Sea Link

Document 9.19 Sea Link DCO notification of change to DCO application

Planning Inspectorate Reference: EN020026

Notification of Applicant's Intention to Submit Request for Proposed Changes to the Development Consent Order Application

Appendix C: Change 3 The Henge, Suffolk Proposed Change Drawing

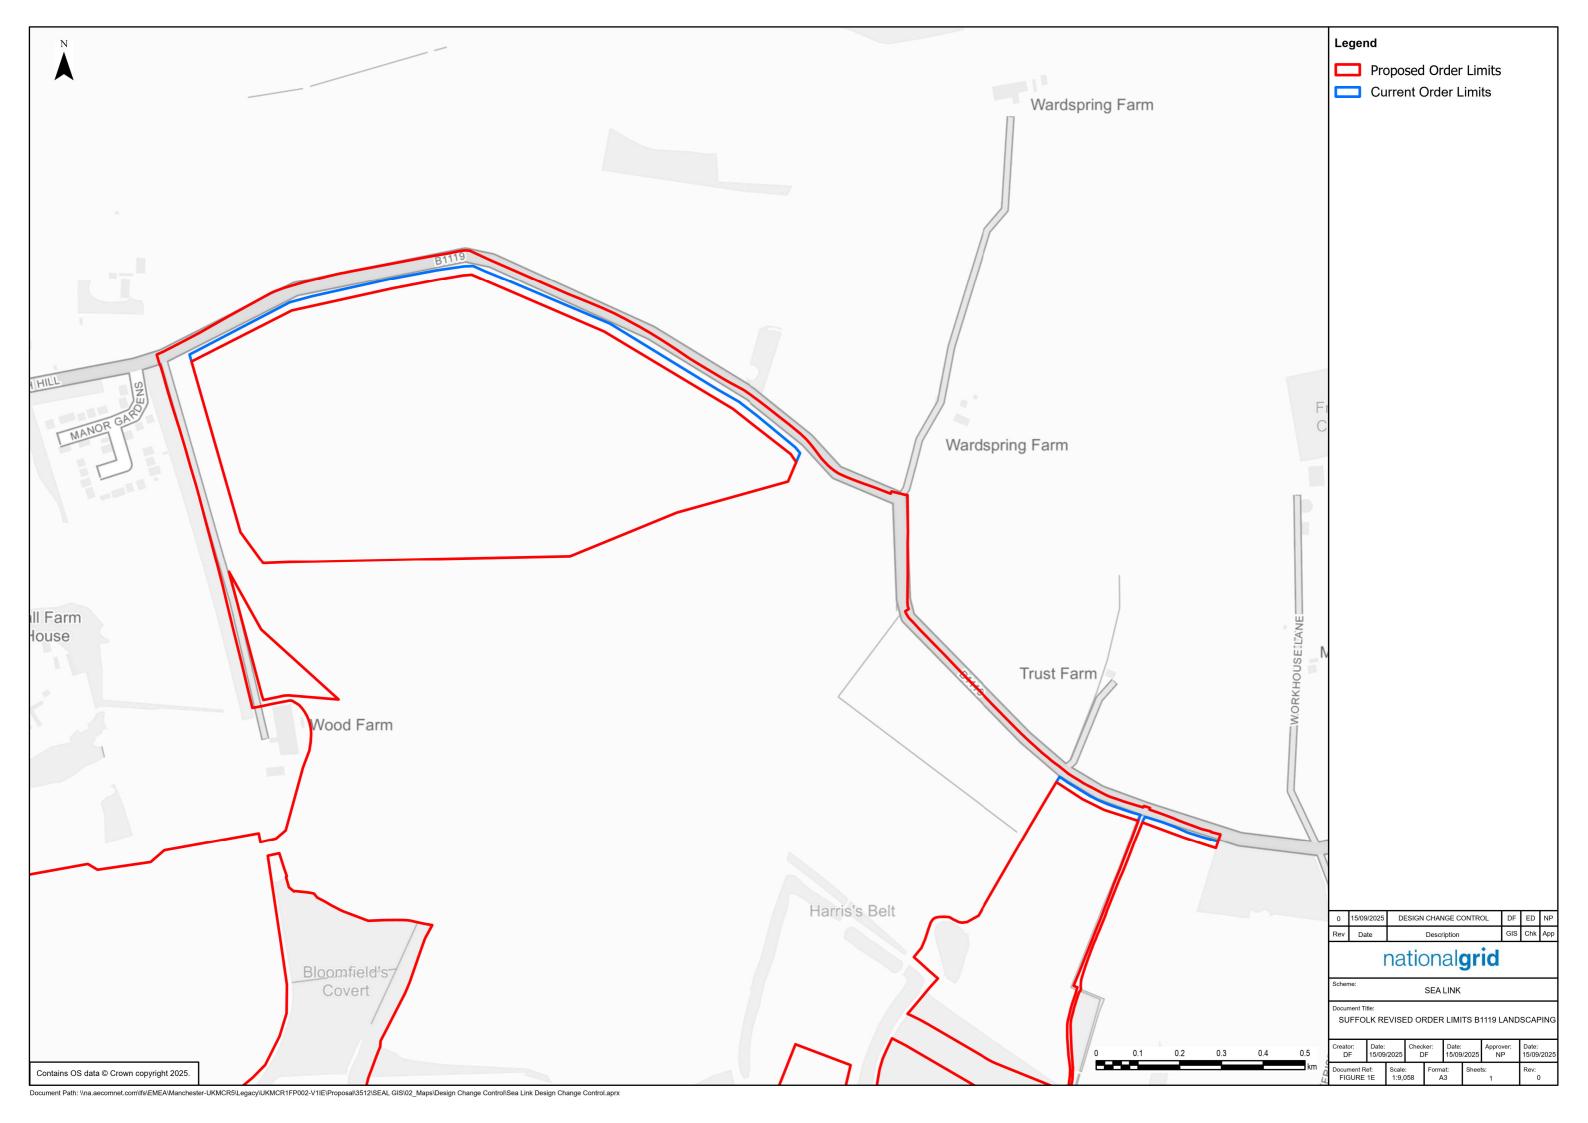
2.1.22 This change proposes to amend the Order limits to remove the potential Neolithic hengiform monument feature from the Order limits and to introduce additional land to enable the underground cable to be routed around the feature. The proposed

- revision to the Order limits would allow a 30 m buffer between the amended Order limits and the henge, as shown on the figure in Appendix C.
- 2.1.23 The henge was recorded during trial trenching completed in July 2025, after submission of the DCO application. A feature in this location was previously identified through geophysical survey but was assessed by heritage specialists as likely to be a partial enclosure associated with a prehistoric field system. Therefore, the geophysical survey did not identify this area as being an area of high risk for heritage and was therefore not prioritised in the trial trenching programme. This area was one of the last to be surveyed because it was not associated with one of the more substantial elements of development (e.g. a substation), it was not identified as being high risk for heritage, and was timed to reduce damage to crops.

- 2.1.25 Evaluation trenching undertaken post-DCO submission identified that the enclosure was more substantial than had been thought following the geophysical survey and potentially represents a henge monument. Engagement with Historic England and the County Archaeologist for Suffolk was completed in July 2025 following the trial trenching, and they have considered that the asset meets some or all of the criteria (rarity, survival, group value etc.) for scheduling. The Order limits at this point in the cable corridor are narrow because efforts were made to reduce the land required for construction of the project in line with requirements of the Compulsory Acquisition process. The narrow Order limits at this point means that at present the underground cable would pass through the henge feature, potentially leading to significant adverse effects on the heritage asset. The current design also includes a haul road along the cable alignment for construction purposes, which is also likely to adversely affect any above ground elements of the feature.

- 2.1.27 Therefore, the only option that the Applicant is confident will avoid a significant adverse effect on the henge feature is to expand the Order limits to enable the cable to be re-routed around the feature. Archaeological work to date provides a good indication of the size of the asset and it would be unusual to find significant archaeology in close proximity to the henge due to the form of the monument and the way henges were used, as well as information we have from evaluation trenching that has been undertaken to date. However, given that the area outside the current Order limits has not yet been fully subject to geophysical survey or trial trenching, it is necessary to include sufficient flexibility within the Order limits for the cable to reroute either to the east or the west of the asset, and to allow sufficient space to microsite the route alignment. Geophysical survey is planned for September/ October 2025 to provide further information on the heritage value of the proposed additional areas, which will provide further information to assess the impact of potential amended alignments on heritage. Targeted trial trenching will be scheduled based on the findings of the geophysical survey and will provide information to inform archaeological mitigation and final cable routeing implemented at construction. The Applicant would only exercise Compulsory Acquisition powers over land required for the final alignment, as confirmed during detailed design after trial trenching is complete.

- 2.1.30 The proposed change would increase compliance with national and local planning policy through avoiding harm or loss of a heritage asset, the henge.
- 2.1.31 National Grid is engaging with landowners of affected parcels to explain the requirement for additional land and seek agreement for the proposed change. However, given the timescales and land interests involved it has not been possible to gain their consent for the proposed change in advance of this Change Request notification.
- 2.1.32 The proposed change to the Order limits is shown in on the figure in Appendix C, with the potential henge shown as a circular feature on the plan.
